RKI EXPLORATION AND PRODUCTION, LLC IS REQUESTING TO PLUG AND ABANDON THE SANTA FE FEDERAL 1.

Santa Fe Fed #1 Plug and Abandon Procedure

API # 30-015-25590
Property # NA

**Santa Fe Federal 1
Proposed WBD**

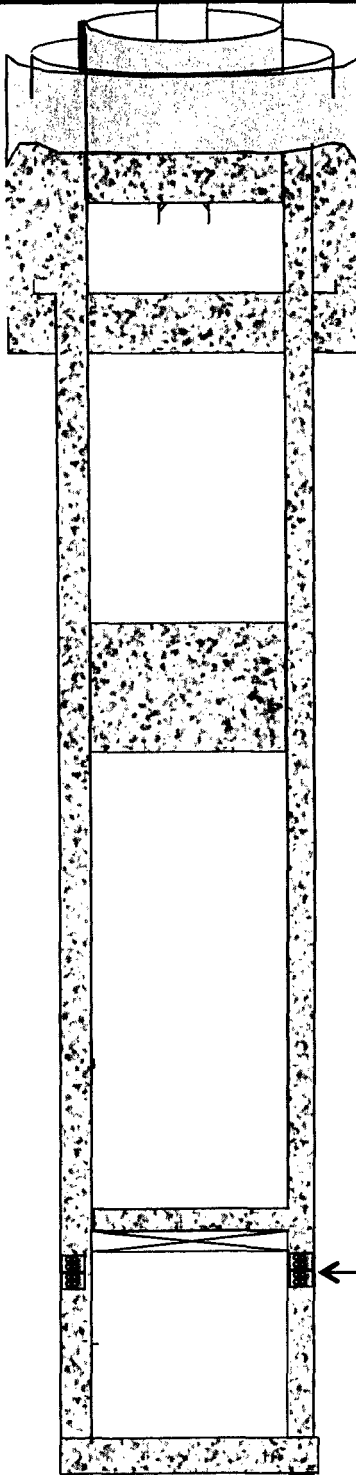
- 7) WOC & Tag ** Add plug (DVT) From 5081' - 4931', WOC Tag.*
- 8) PU & LD tbg. to 2850' - Spot 45 sxs from 2850' - 2450'.
- 9) PU & WOC - Tag cmt. - **Max tag 2450.**

- 10) RU WL & Perforate 4 holes @ ⁶²⁰482'. RD MO wireline.
- 11) RIH w- Pkr & tbg. - set Pkr @ 240' - Attempt to establish pump rate. Squeeze ~~40~~ ^{Adequate to bring cmt} ~~40~~ ⁶²⁰ Class C Cement (14.8 ppg, 6.3 ^{TO 382} gps, 1.32 cfs yield).

- 12) WOC & Tag @ ~~432~~ ³⁸²
- 13) **If good cement bond and unable to squeeze - Spot ~~40~~ ^{Adequate 670} sxs from ~~500~~ ³⁸² to surface. If tagged cmt. @ ~~432~~ ³⁸² - spot 25 sxs cmt. from 150' to surface.**
